Corrigendum - 7 dated 26/05/2025 to CPC Tender No. BHEL/CPC/SGL/EPC-AHP/25/082

Corrigendum - 7 dated 26/05/2025 to CPC Tender No. BHEL/CPC/SGL/EPC-AHP/25/082 for the work of “EPC package for Ash Handling Plant at Singrauli STPP Stage-III (2X800 MW)”.

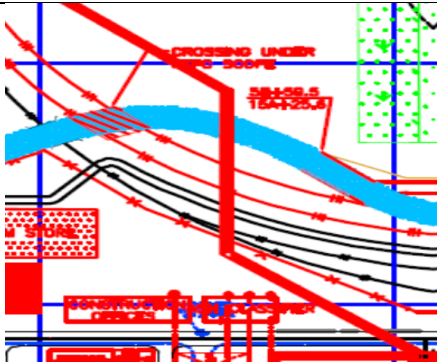
32	Clause 1.01.06 (E) a & e	The fly ash coming from ESP hoppers or buffer hoppers of both units shall be led to a classifier silo of capacity 250 tonnes The capacity of the fine ash hopper (01 no) and coarse ash hopper (02 no) shall be 300 Tonnes each.	Please confirm whether Fine Silo & Coarse Ash Silo capacity is 250T or 300 T.	Specification is clear. Fly ash and Coarse ash hoppers shall be 300 T each
